Project No. 12149

***Re: Proposed Modifications to Adopted VMC Secondary Plan  
7551 and 7601 Jane Street – Vaughan Square Centre  
Pandolfo Group***

## Proposed Modifications to Adopted VMC Secondary Plan

*7551 and 7601 Jane Street – 785345 Ontario Limited, L & M Portfolio Holdings*

Figure 1 – Schedule A, Urban Growth Centre

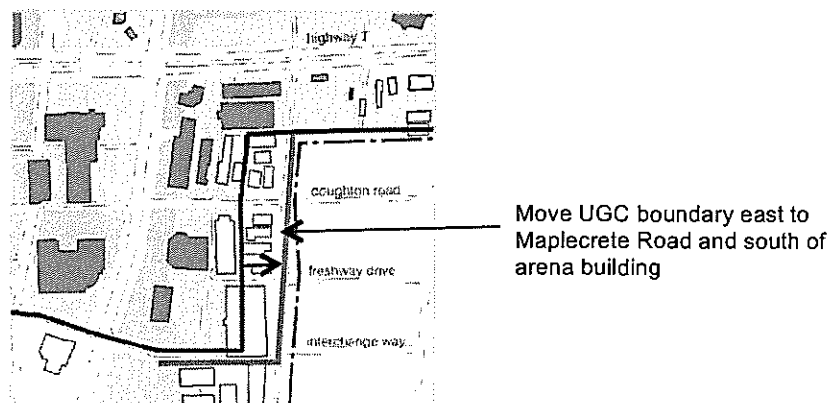
1. Schedule A - Move the Urban Growth Centre (UGC) boundary east to Maplecrete Road to include the subject site in its entirety. (note: schedule 1 to the parent official plan would also require modification to reflect this change.) (see page 2, figure 1)

The modifications to Schedules A and J would expand the UGC and 25 storey/4.5 FSI permissions further east to about midway between the block west of Maplecrete Road. While we are supportive of this modification, we request that the Urban Growth Centre boundary should be expanded to the eastern extent of the VMC (Maplecrete Road)(See Figure 1). In line with that, the higher density 25 storey/4.5 FSI area would also be shifted to reflect the UGC boundary along Maplecrete Road (See Figure 2).

Figure 2 – Schedule J, Height and Density Parameters Modifications

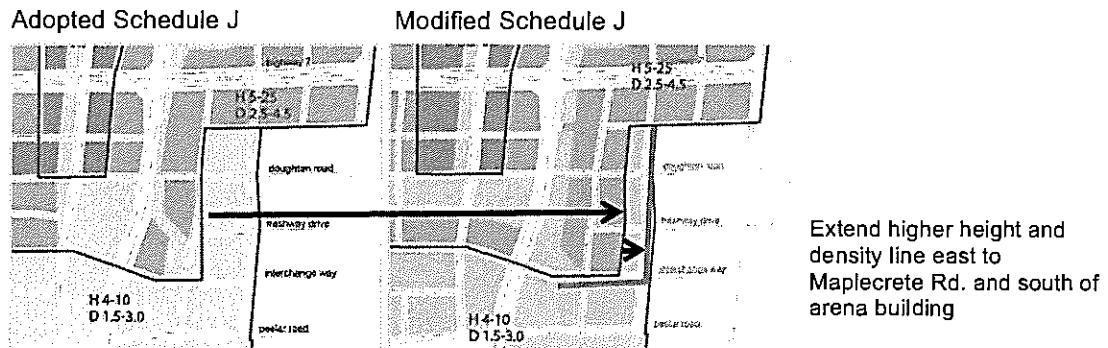
2. Schedule J - Move the higher density area (4.5 FSI/25 storeys) boundary east to Maplecrete Road to reflect the modified UGC boundary. (see page 3, figure 2)

In our view there is an additional benefit to expanding the UGC and higher density and height parameters for the following reasons:

- The current UGC boundary straddles the property. In order to allow for the orderly development of the property, we believe that the entire property should be included in the UGC and the higher density area.

Figure 3 – School Location

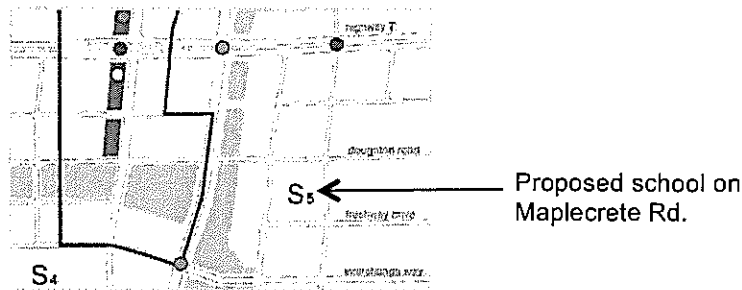
- The expansion of the height and density parameters would not result in any detrimental land use compatibility issues. Specifically, given the proposed location of the school site northeast of the subject site, which is directly adjacent to the employment area, there does not appear to be any need for transition to the east in terms of height and density (See Figure 3).

Figure 5 – Street Network Modification

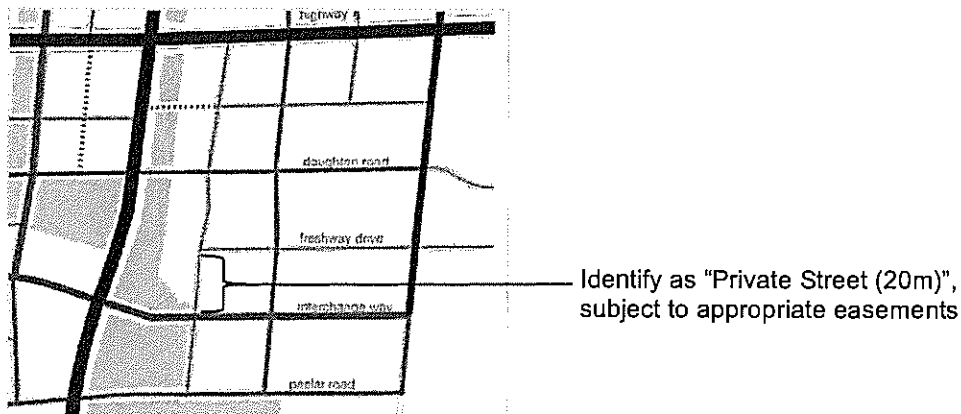
3. Schedule C - Show a "private street" between Freshway Drive and Interchange Way where there is currently a "local street" shown west of Maplecrete Road. (see page 5, figure 5)

- There are two streets proposed to bisect the subject site, one east-west street and one north-south street. Given that the subject site would be bounded by four public streets with four access points and given the unknown alignment of the Black Creek floodplain remediation line, we request that the southerly extent of the north-south street between Freshway Drive and Interchange Way be shown as a 20m "private street" subject to appropriate easements on Schedule C as indicated in Figure 5.

Figure 6 – Street Network Alignment at Freshway Drive and the proposed new North-South street

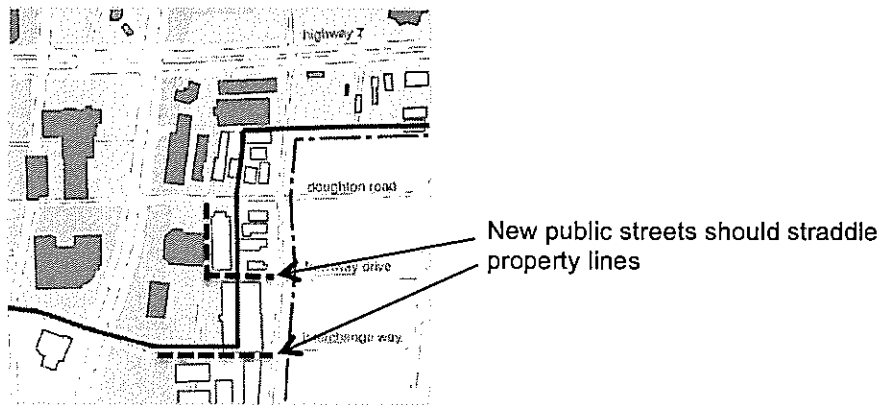
4. Modify policy 4.3.5 to clarify that the dedication of land for new public street rights-of-way will be shared between property owners where appropriate and possible. (see page 6, figure 6)

- In addition, the alignment of the proposed public streets adjacent to the subject site should be amended to more closely reflect the intent that public streets should be shared between different properties in terms of future dedications (See Figure 6).

In our view, the most appropriate method to ensure the sharing of road dedications would be to modify policy 4.3.5 by adding the following wording shown in bold italics below:

“New collector and local roads identified in Schedule C shall be identified in all approved plans within the VMC and shall be conveyed to the municipality as a condition of approval of draft plans of subdivision and site plan applications, at no cost to the City ***and, where possible, streets should straddle property boundaries so that they are shared.***”

Figure 7 – Schedule G showing Remediation Line

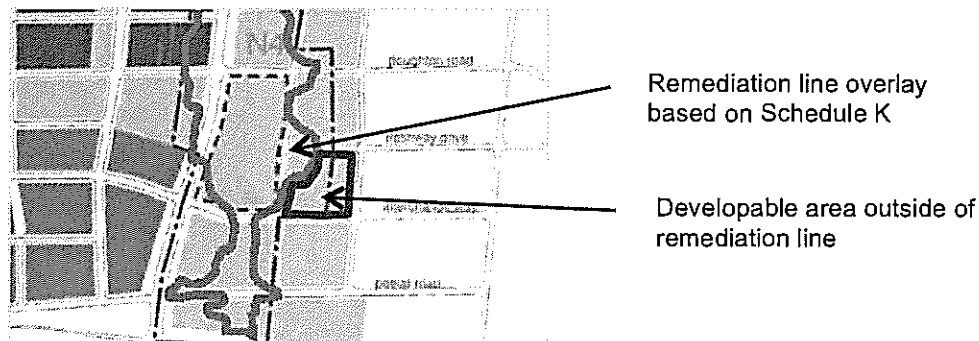
5. Modify the boundary line of Special Study Area B to reflect the more accurate line delineated on Schedule K as the "Black Creek Remediation Area". (see page 6, figure 7)

- The Special Study Area policy 8.4.4 states that “Properties partially or wholly within Special Study Area B, but entirely outside the floodplain, are exempted from the development restrictions applicable to lands in the study area.” In our view, the restrictions should only apply to the lands within the floodplain, despite the overall property boundaries. In this regard, we request that Schedule G be amended to modify the Special Study Area line to align with the flood remediation line as identified on Schedule K (see Figure 7 below).

Figure 8 – Original Proposed Black Creek Alignment

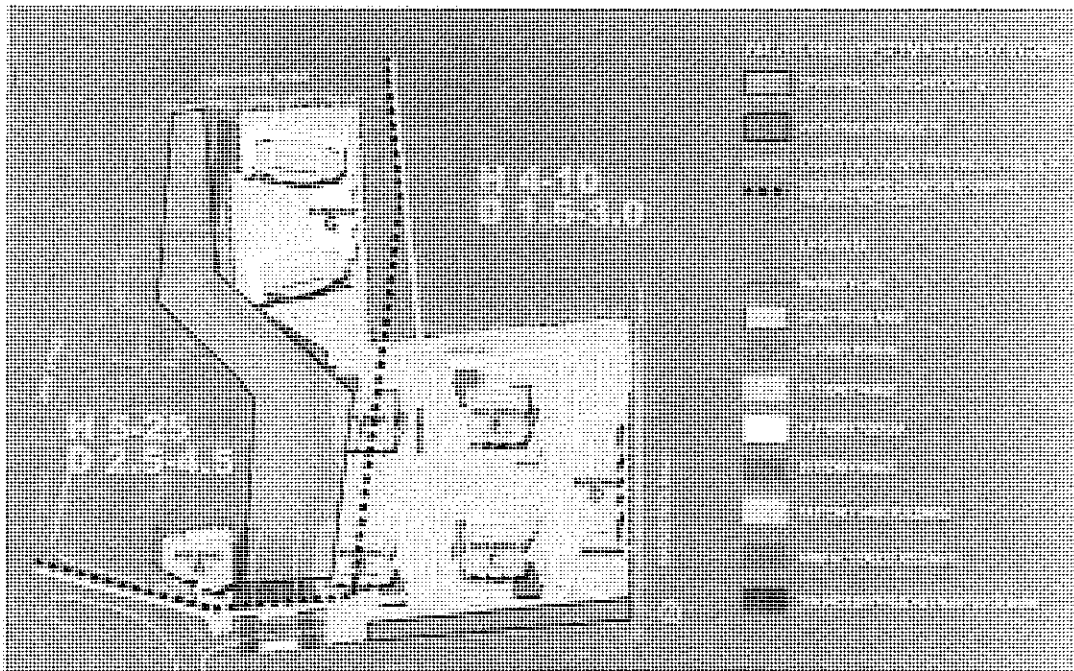
6. Depending upon the final determination of the Black Creek alignment we may have further comments as the alignment will affect the development potential of this property. (see page 7, Figure 8)

Depending upon the final determination of the Black Creek alignment we may have further comments as the alignment will affect the development potential of this property. We will have further comments if the Black Creek alignment remains in its current location as shown in Figure 8, which would substantially diminish the developable area, especially once the potential buffer, park and new street network are accounted for.

Schedule E

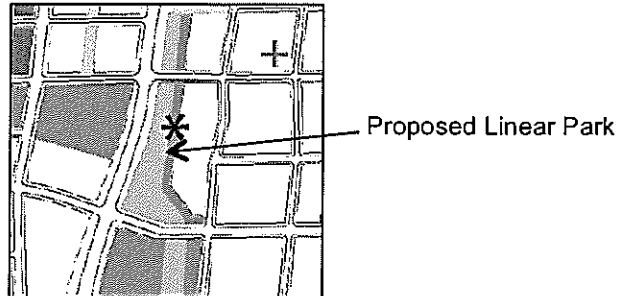
7. Modify policy 10.2.9 as necessary to provide that the width and location of the Linear Park east of Jane Street is not defined until such time as the location and buffers of Black Creek are determined. (see page 7)

While we are generally supportive of a linear trail on the east side of Black Creek, we object to the proposed width of 25 metres. In our view, the purpose of this park is to

provide a walking or multi-use trail connection between Highway 7 and the open spaces areas to the south and that to fulfill this purpose a width of approximately 6 metres is adequate given that the linear park may encroach onto private properties. However, if it is intended that this park be more substantial for other purposes, we would have no issue with the width, subject to it being provided entirely on City property, especially given the uncertainty of the ultimate alignment of the Black Creek floodplain and the resulting potential loss of developable area.

In order to alleviate the concern respecting the proposed location and width of the linear park, we suggest that Policy 10.2.9 be modified to include the following new subsection:

*“10.2.9(7) – The final location and width of the Linear Park east of Jane Street will be determined once the limit of the upgraded pond, naturalized creek channel and associated buffer have been defined within the approved remediation strategy.”*

## URBAN GROWTH CENTRE BOUNDARY

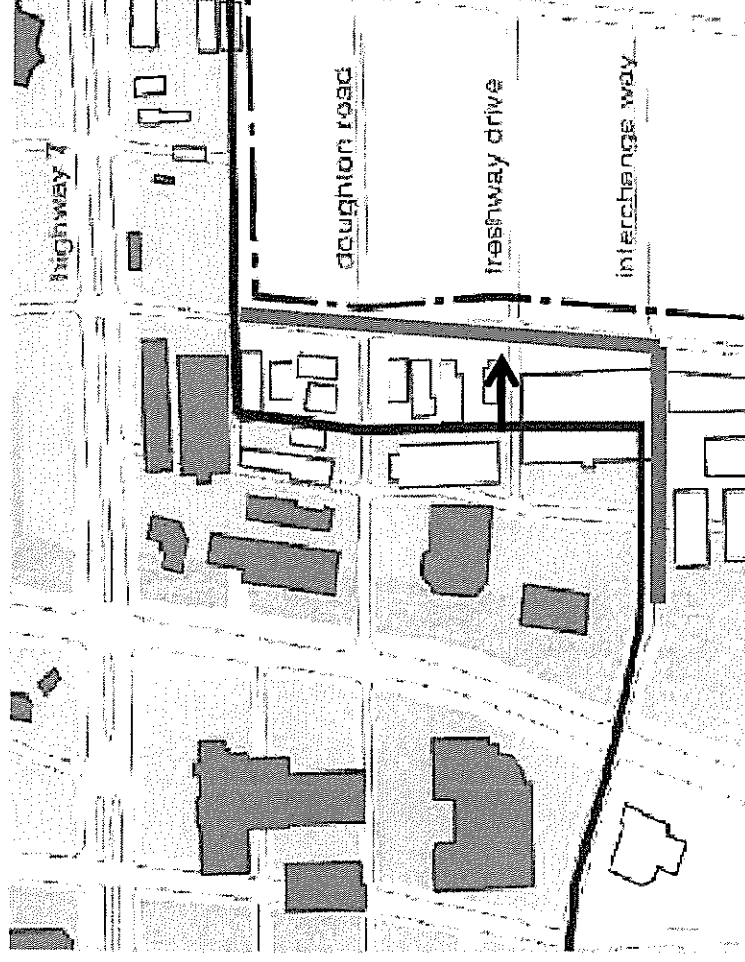
- 1) Schedule A - Move the Urban Growth Centre (UCG) boundary east to Maplecrete Road to include the subject site in its entirety

Modified Schedule J

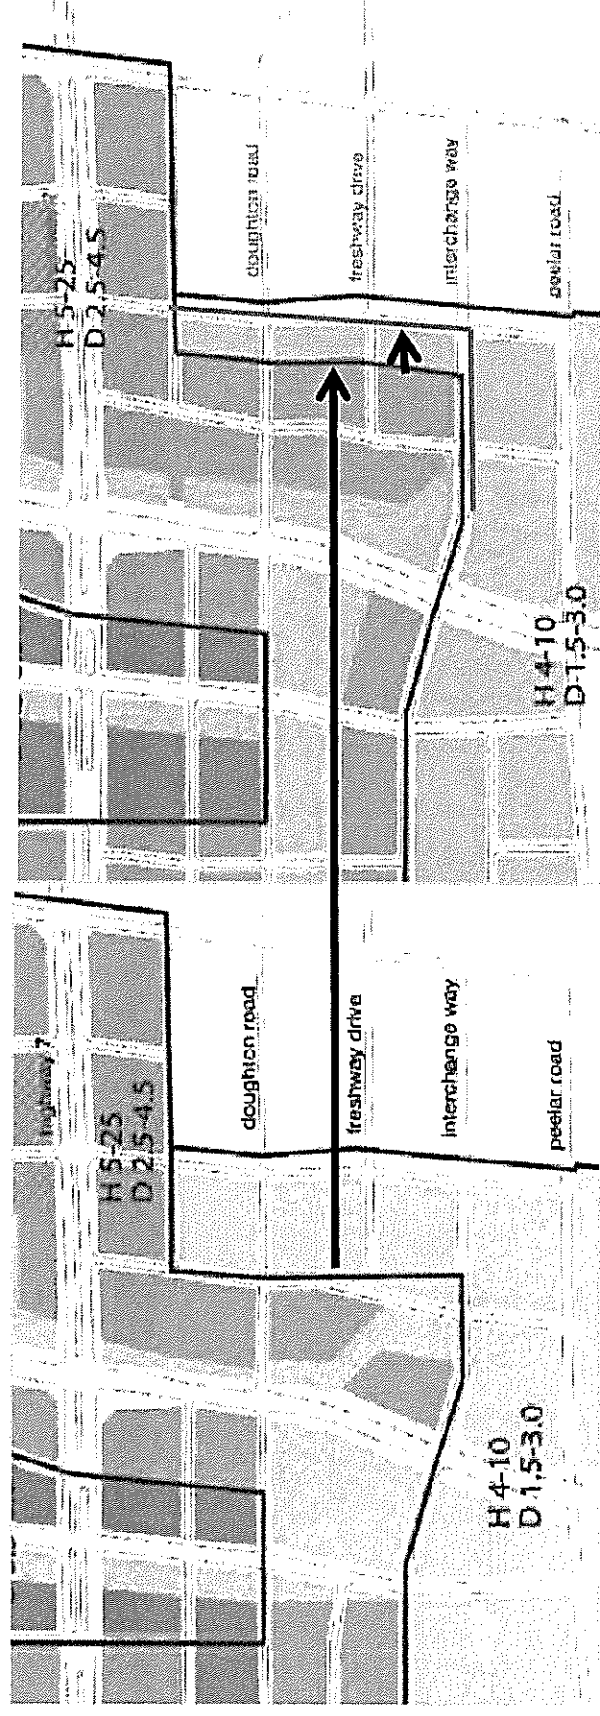
- 2) Schedule J – Move the higher density area (4.5 FSI/25 storeys) boundary east to Maplecrete Road to reflect the modified UGC boundary

## STREET NETWORK

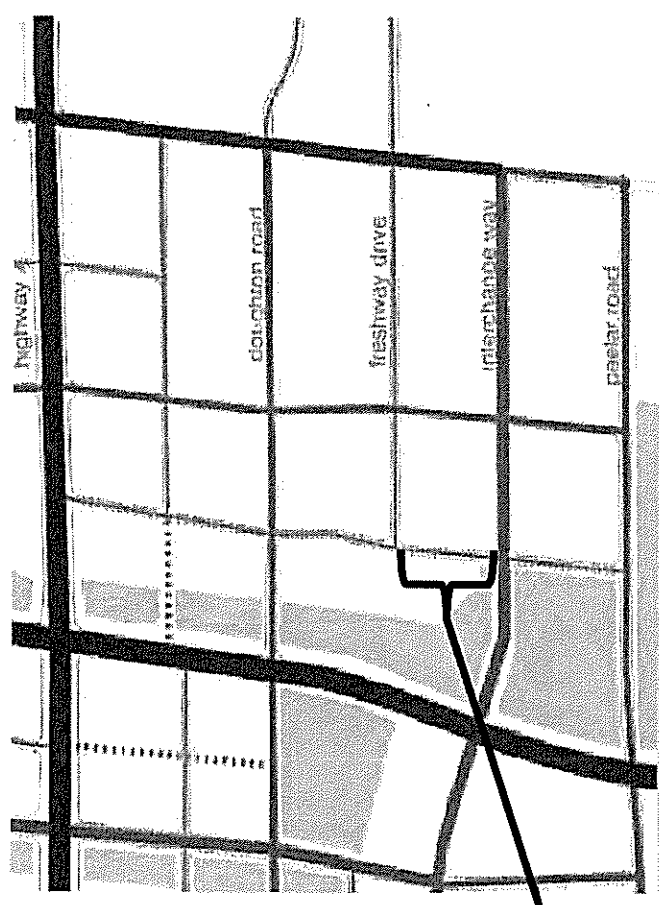
- 3) Schedule C – show a “private street” between Freshway Drive and Interchange Way where there is currently a “local street” shown west of Maplecrete Road

Identify as “Private Street”, subject to appropriate easements

## STREET NETWORK

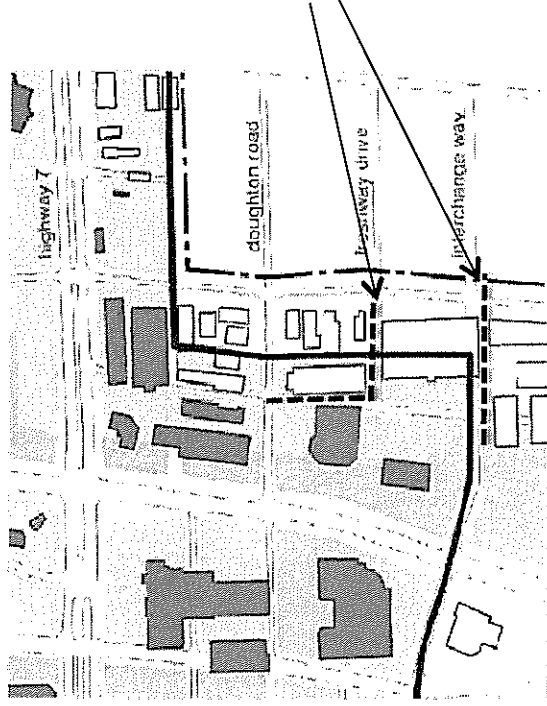
- 4) Modify policy 4.3.5 to clarify that the dedication of land for new public street right-of-way will be shared between property owners where appropriate and possible

New public streets should  
straddle property lines

“New collector and local roads identified in Schedule C shall be identified in all approved plans within the VMC and shall be conveyed to the municipality as a condition of approval of draft plans of subdivision and site plan applications, at no cost to the City **and, where possible, streets should straddle property boundaries so that they are shared.**”

## LAND USE PRECINCTS

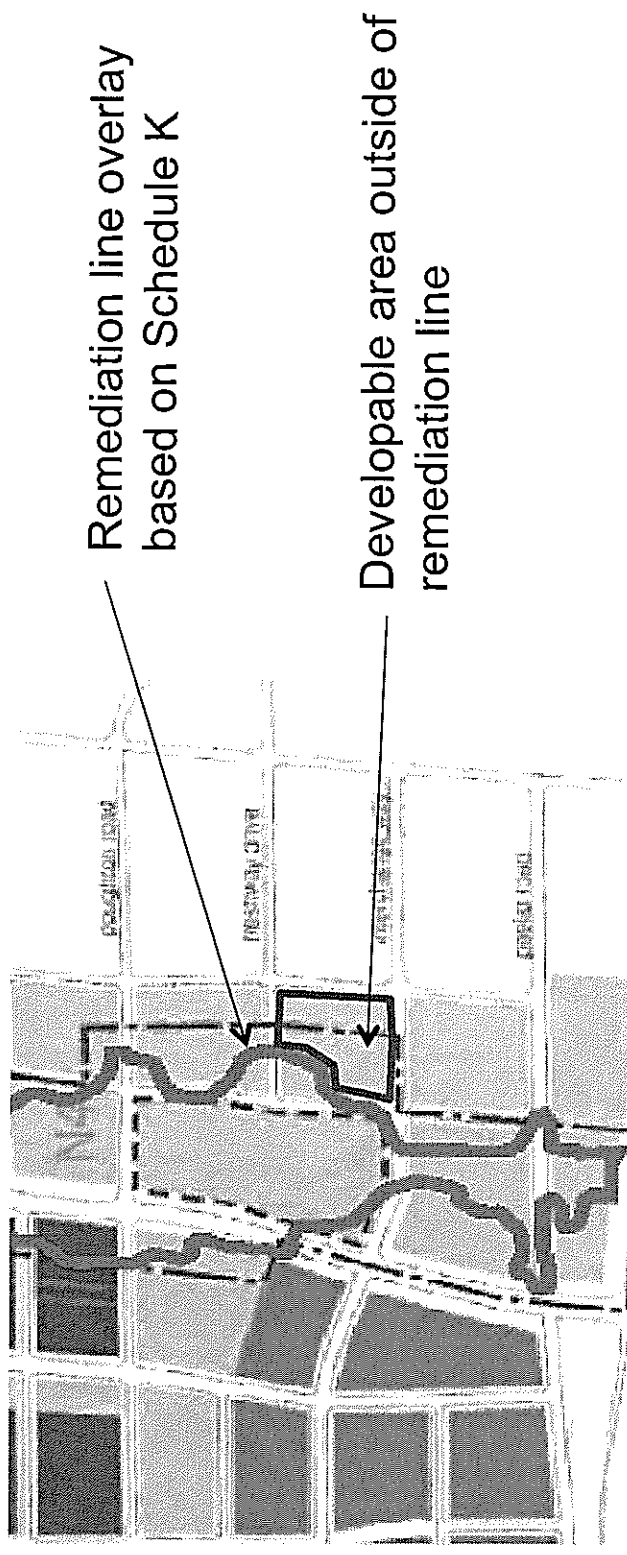
- 5) Schedule G - Modify the boundary line of Special Study Area B to reflect the more accurate line delineated on Schedule K as the “Black Creek Remediation Area”

## MAJOR PARKS AND OPEN SPACES

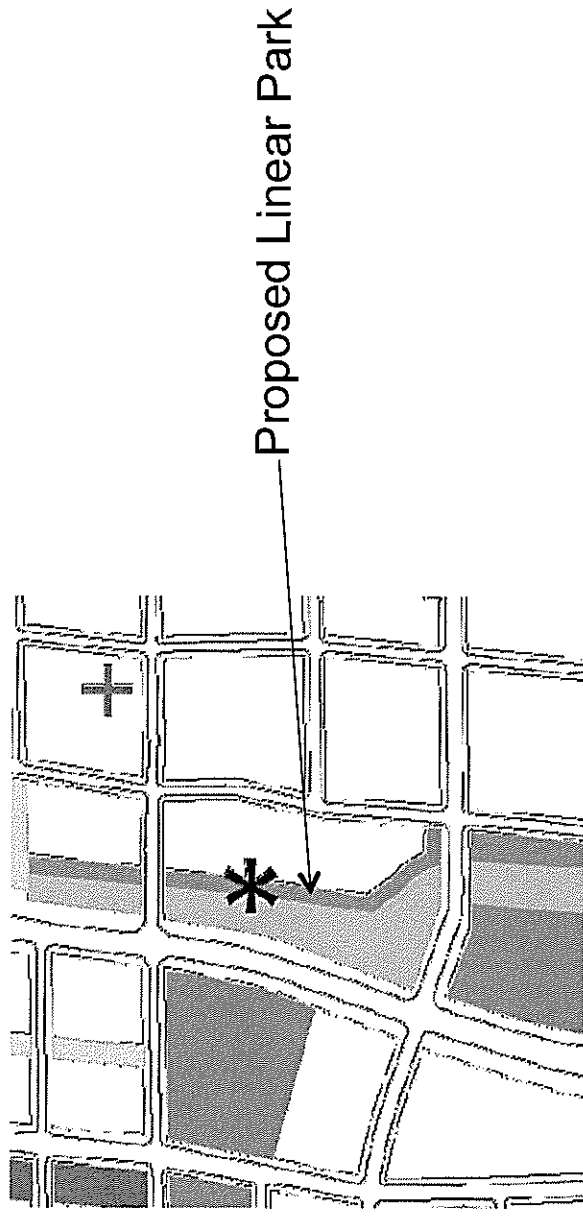
- 7) Modify policy 10.2.9 as necessary to provide that the width and location of the Linear Park east of Jane Street is not defined until such time as the location and buffers of Black Creek are determined
